Access Compliance Report

Public Rights-of-Way

(Curb Ramps)

Intersection ID: 17085	Main Street: CROYDON_RD	Cross Street: SELWYN_AV	Location: NE
ADA ID: 0F3833A4F7B6	Ramp Type: PerpDiag	Initial Pass/Fail: Fail	Overall Compliance: No
Severity Score: 13.75			
Codes/Mitigation Info/Possible Solution		Field Measurements/Component Compliance

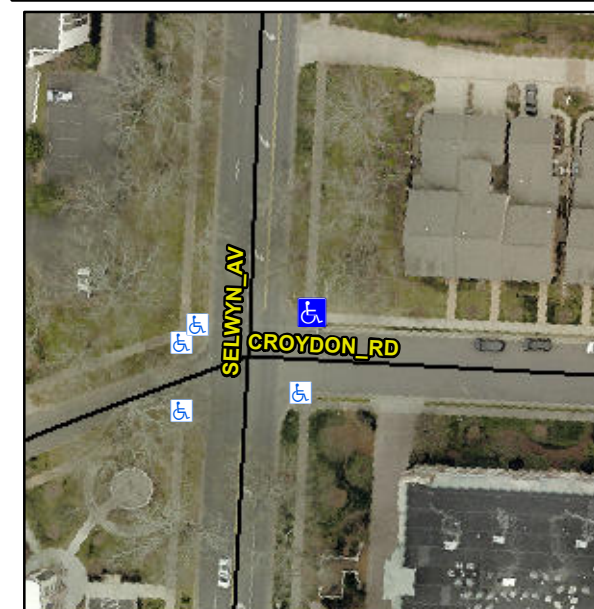
Not Found, R304.2.2, R304.5.3

Compliance	Description	Data	Compliance	Description	Data
N/A	Ramp Length (in)	45.0	No	Ramp Slope (%)	11.7
Yes	Ramp Width (in)	49.0	No	Ramp XSlope (%)	2.7
N/A	Flare Type LT	N/A	N/A	Flare Type RT	N/A
N/A	Flare Slope LT (%)	N/A	N/A	Flare Slope RT (%)	N/A
N/A	Flare Traversable LT?	N/A	N/A	Flare Traversable RT?	N/A
N/A	Landing Length (in)	N/A	N/A	DWS Provided?	N/A
N/A	Landing Width (in)	N/A	N/A	DWS Contrast?	N/A
N/A	Landing Slope (%)	N/A	N/A	DWS Length (in)	N/A
N/A	Landing X Slope (%)	N/A	N/A	DWS Full Width?	N/A
N/A	Landing Curb? (Y/N)	N/A	N/A	DWS Offset (in)	N/A
N/A	Shared Landing?	N/A			
N/A	Gutter Ponding?	Yes	N/A	Gutter Slope (%)	N/A
N/A	Gutter Lip Ht (in)	N/A	N/A	Gutter X Slope (%)	N/A
N/A	Painted X Walk1?	No	N/A	Painted X Walk2?	No
	X Walk 1 Direction	To W		X Walk 2 Direction	To SW
N/A	X Walk 1 Width (in)	N/A	N/A	X Walk 2 Width (in)	N/A
	X Walk 1 Slope (%)	4.4		X Walk 2 Slope (%)	3.5
	X Walk 1 X Slope (%)	0.4		X Walk 2 X Slope (%)	1.6

Remove & Replace Curb Ramp With Two New Directional Ramps or Equivalent.
